INFINIX MOBILITY LIMITED

Subject: FCC Class II Permission change for FCC ID: 2AIZN-X6855
Original Grant Date: 12/12/2024

This is to request a Class II permission change to our Mobile Phone; Model: X6855, FCC ID: 2AIZN-X6855, the device is identical to the previously certified except for the changes as below for details:

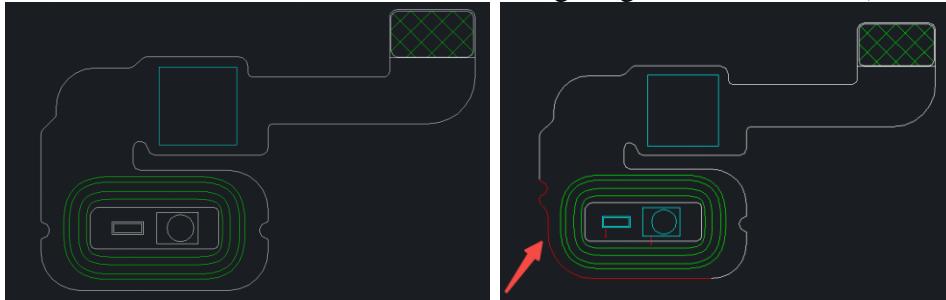
1. WPT Antenna: Enlarged appearance (The total length of the FPC dimensions is increased by 7.55mm, the width is increased by 10mm, and the charging power remains unchanged);
2. MINI LED FPC, Reduced appearance (Cut the red line pointed by the arrow 0.6mm inwards, which will not affect the lighting function or color.)

3. NFC Antenna: change material. (The material is changed from ferrite to absorber material, which does not affect NFC performance)
4. Adding battery supplier.
5. Changed the appearance color of the product.
